# ADDENDUM NO. 2

**JACKSON ELEMENTARY SCHOOL RENOVATIONS**  
**Valparaiso, IN 46304**

**Addendum Two (AD.02)** to the drawings and specifications prepared by Gibraltar Design for **Jackson Elementary School Renovations** for Duneland School Corporation, Chesterton, Indiana.

EL102

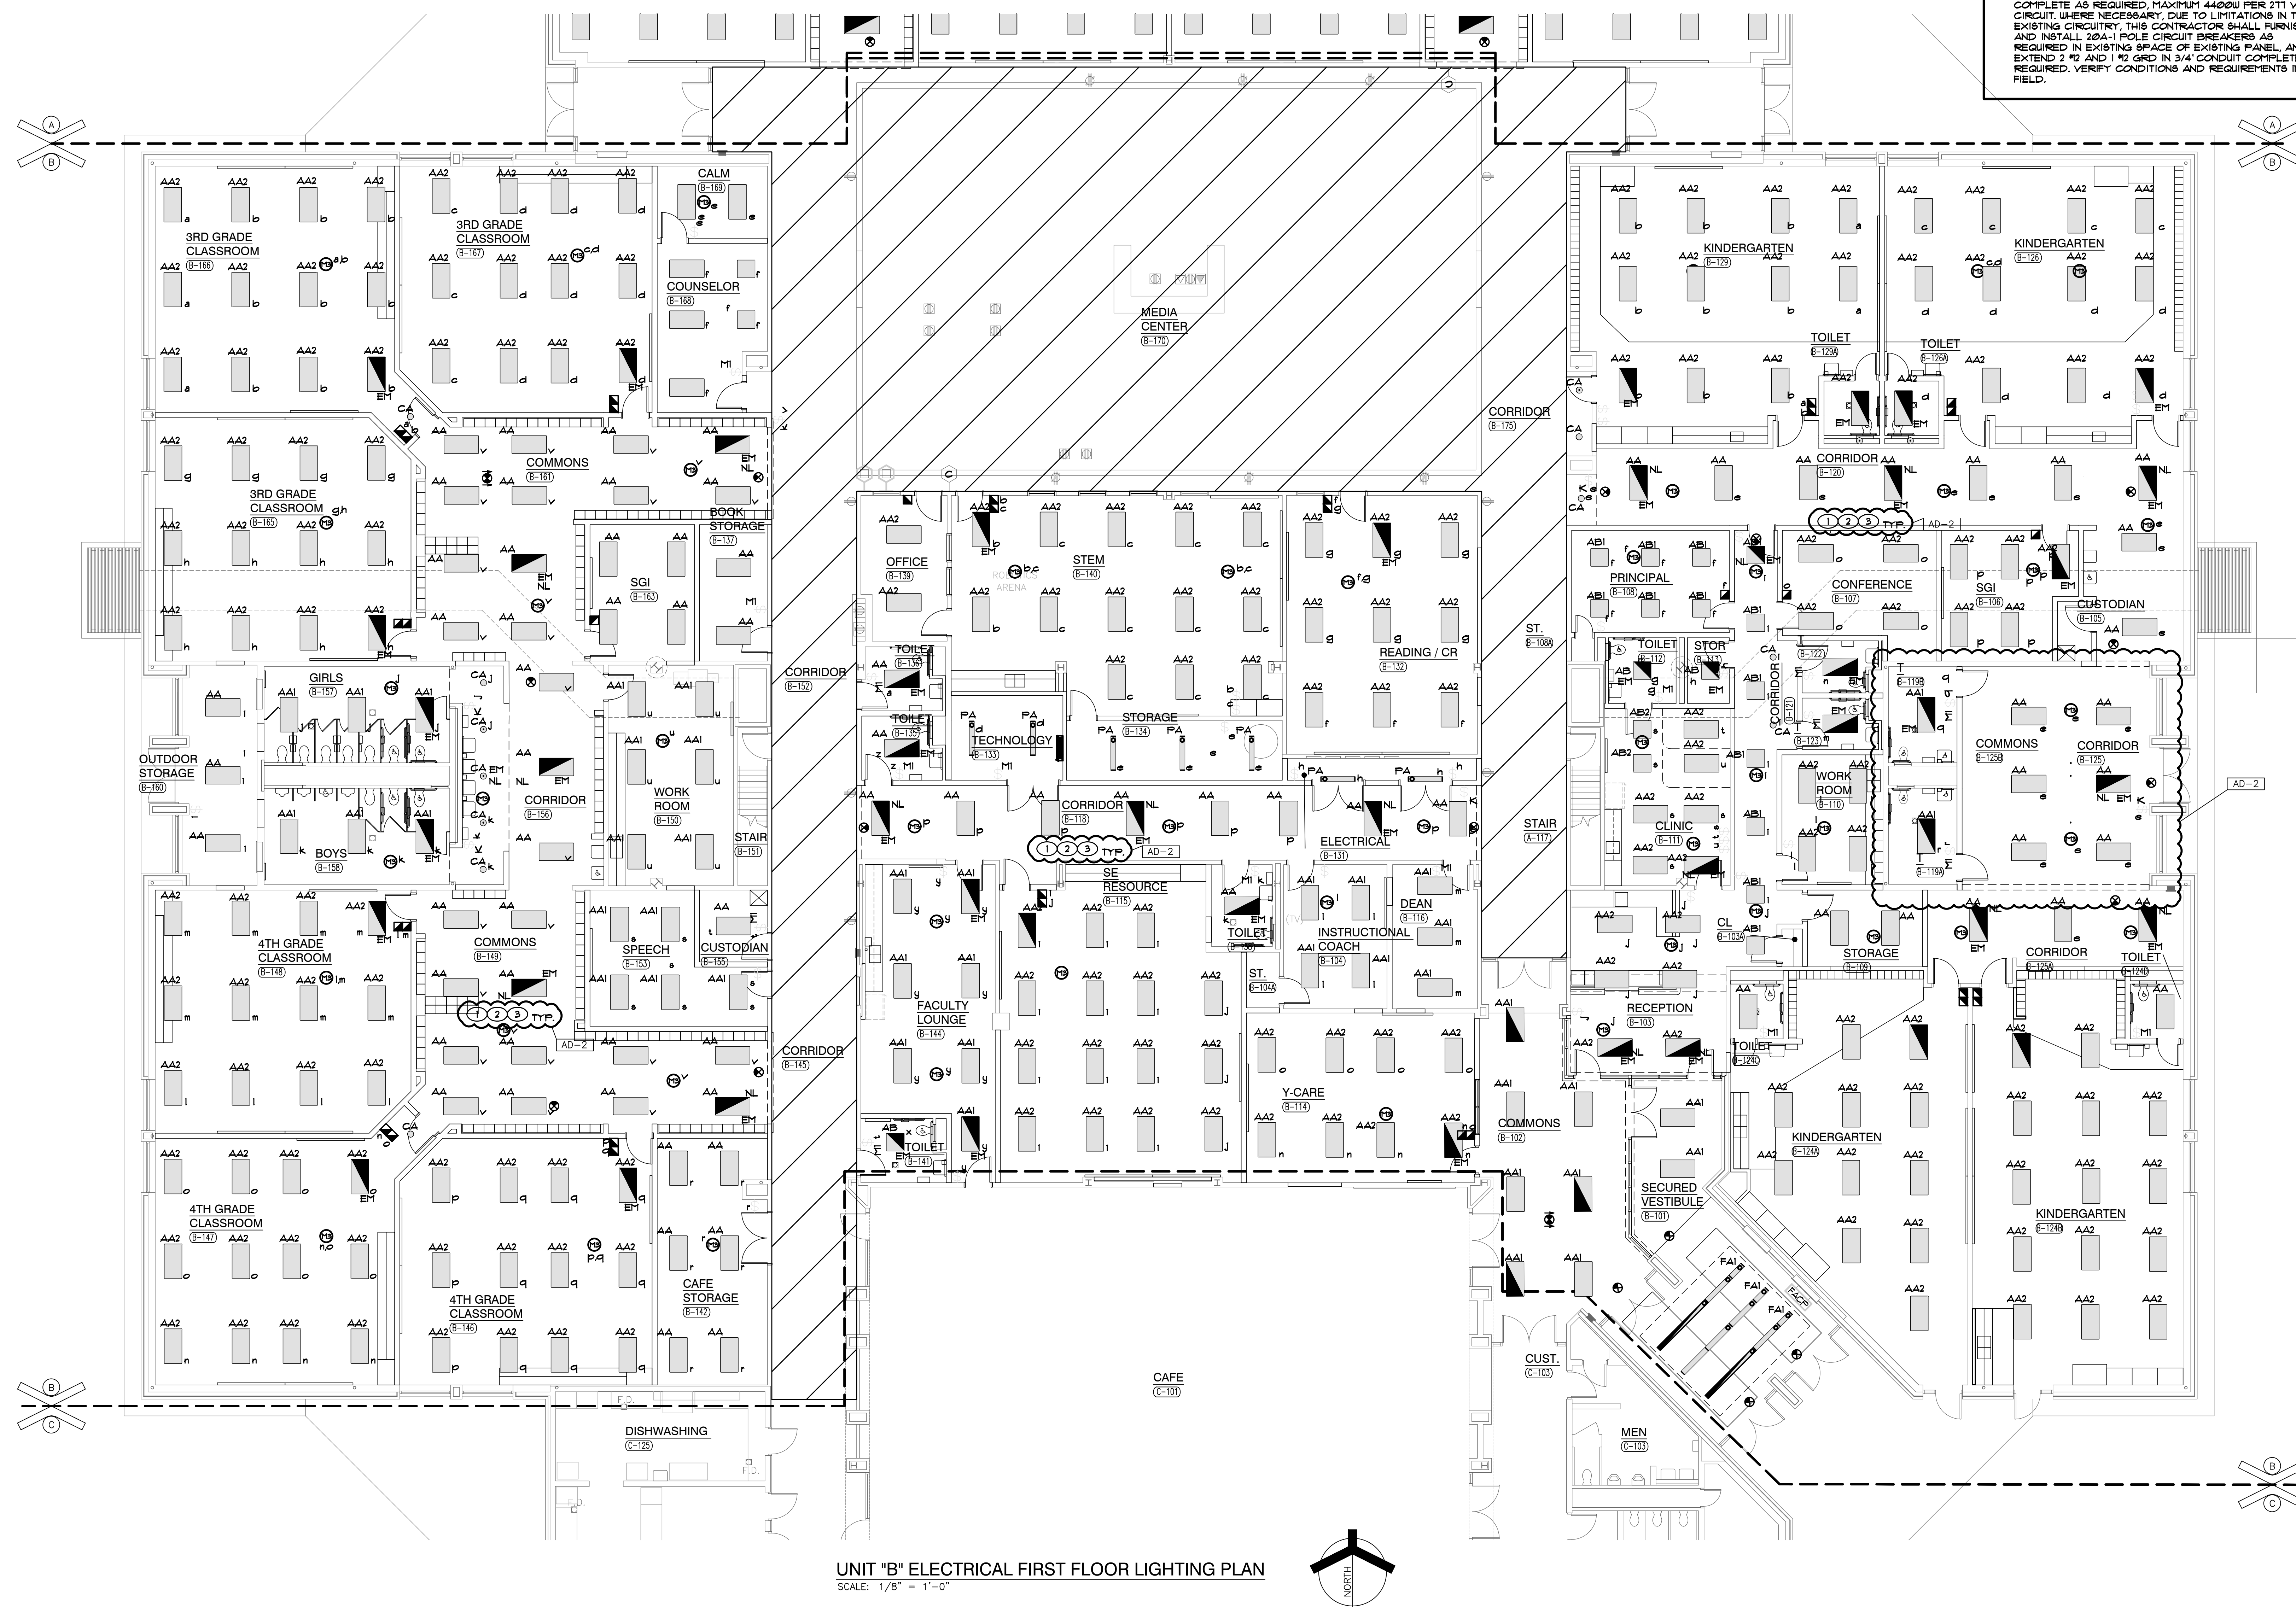
**8. Sheets EL101, EL102 and EL103**

A. Refer to three (3) revised full size drawings, included in this Addendum, for the following revisions:

1. Add circuiting sheet notes.

GIBALTAR DESIGN SHEET  
**B EP102**

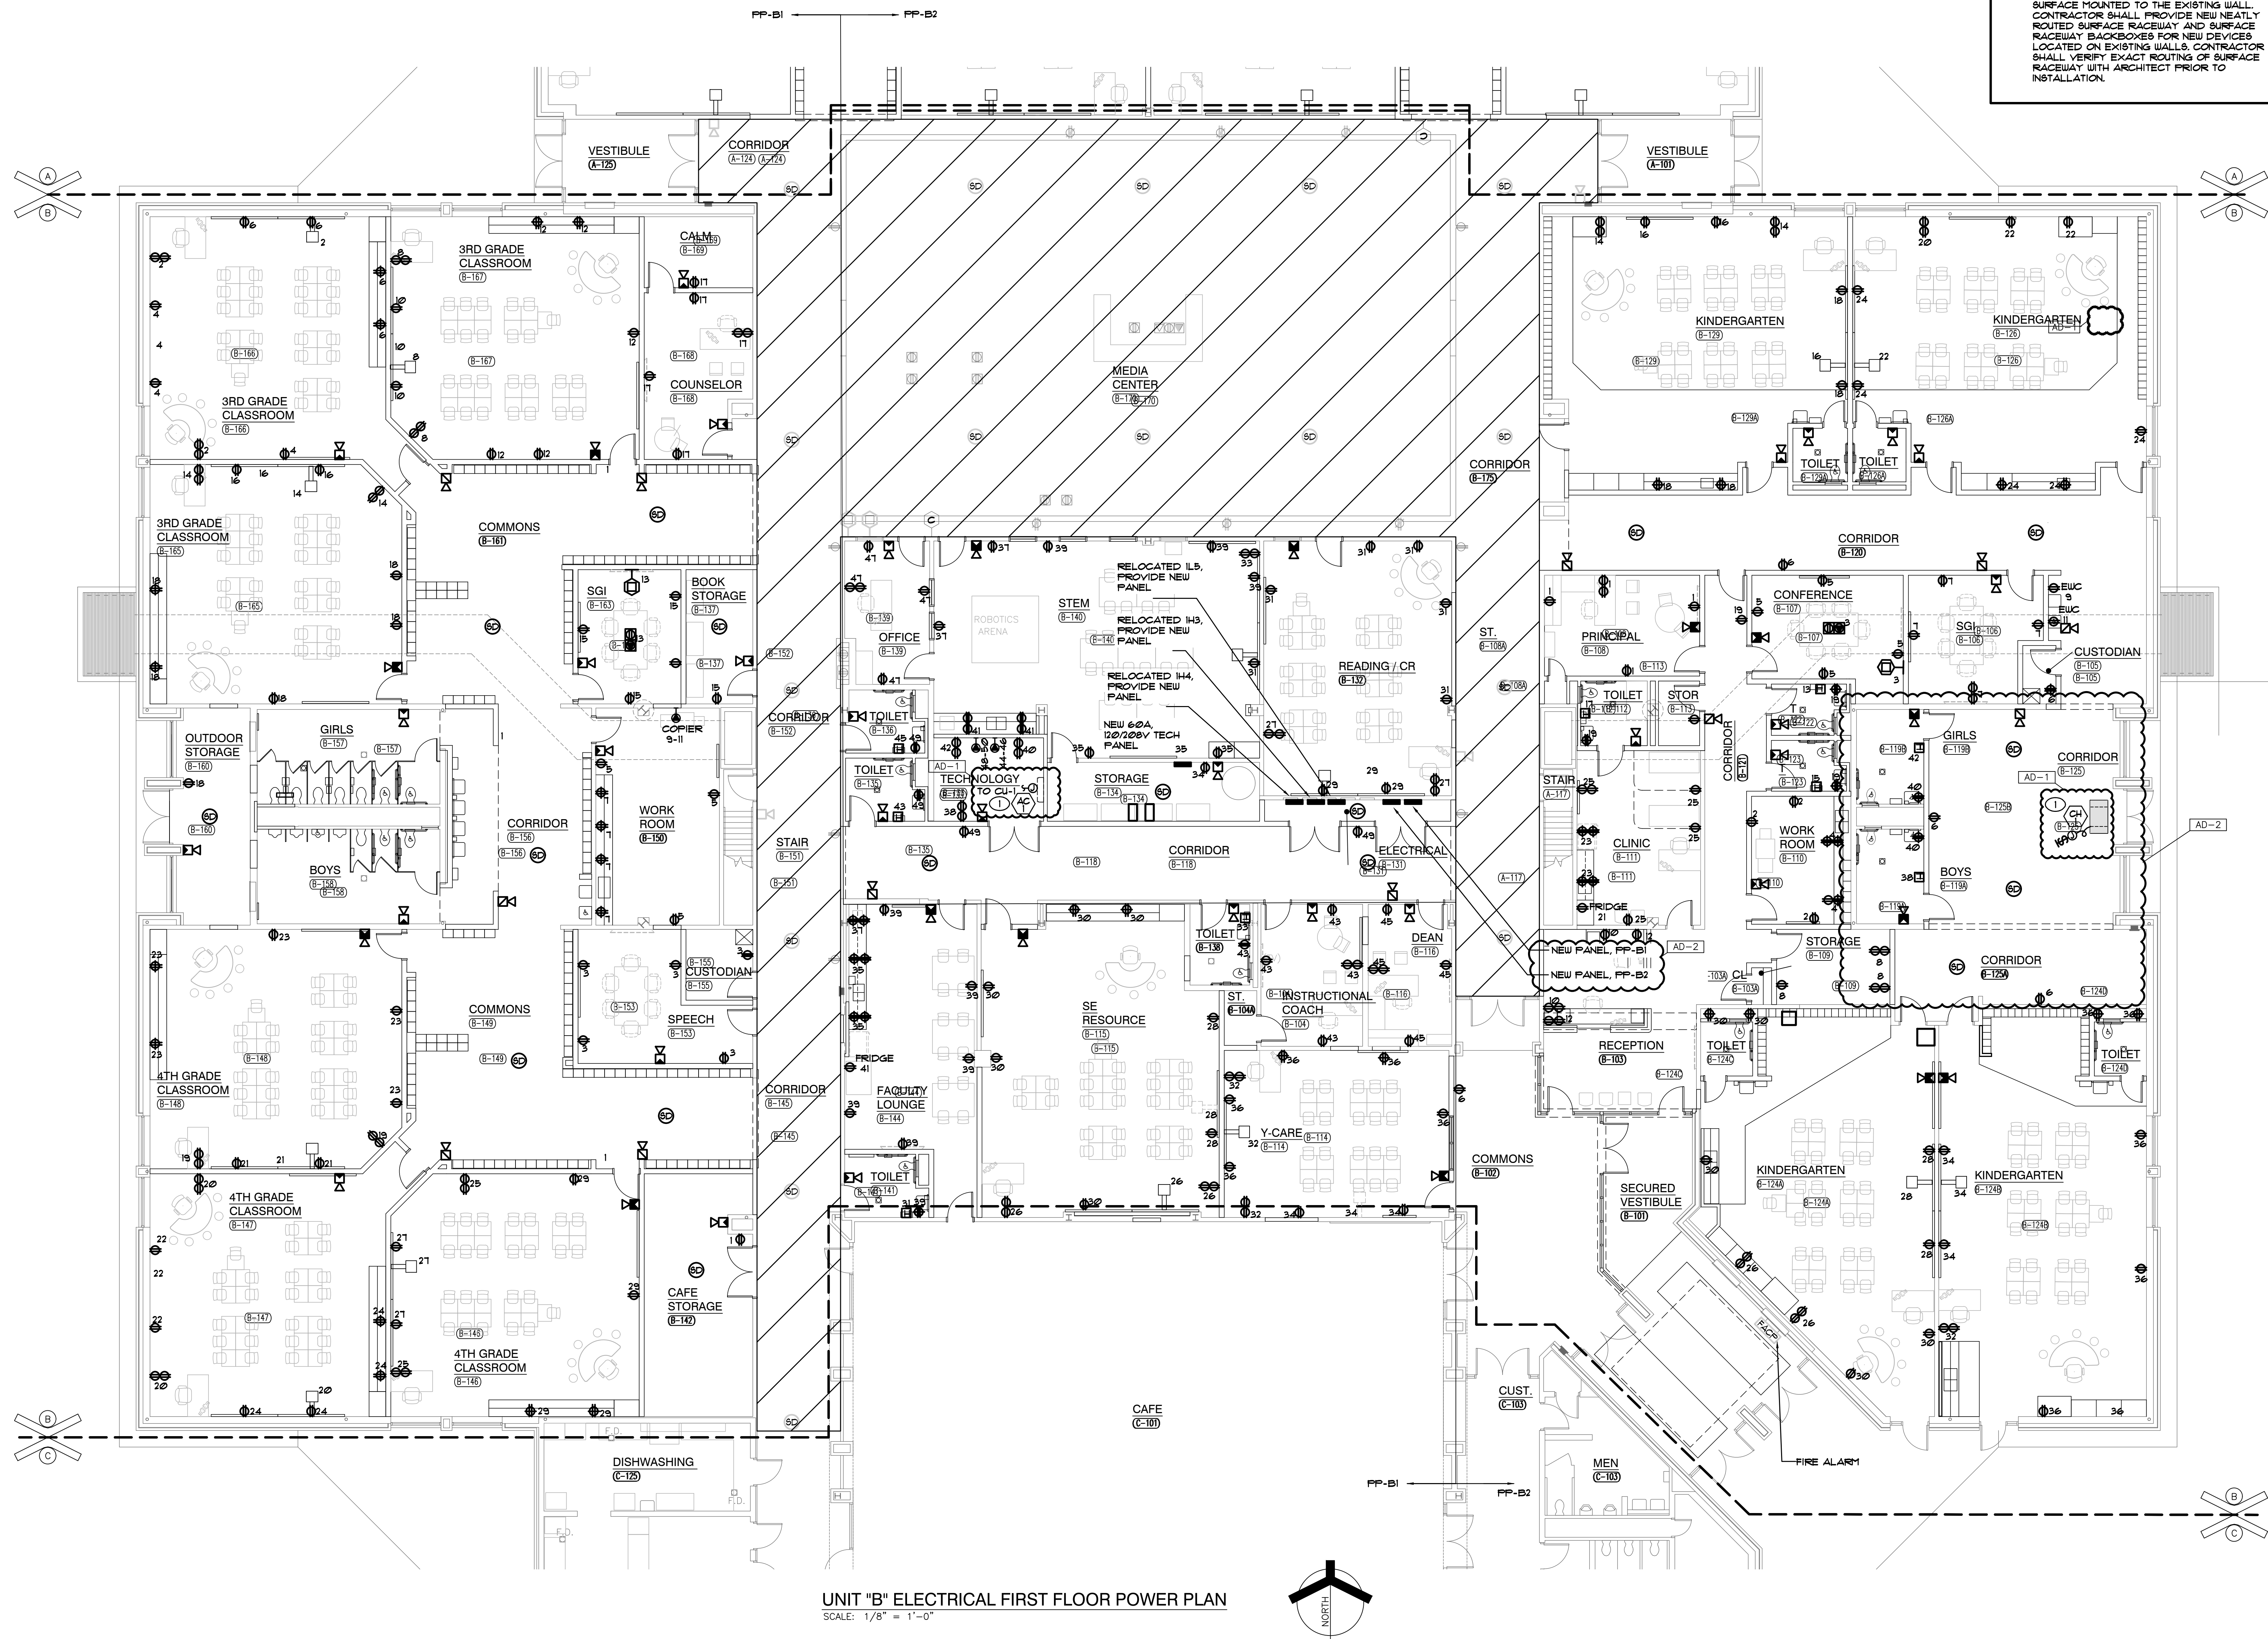
**9. Sheets EP101 and EP102**

A. Refer to two (2) revised full size drawings, included in this Addendum, for the following revisions:

1. Revise panel designations as shown.
2. Delete (1) new panel, not required.
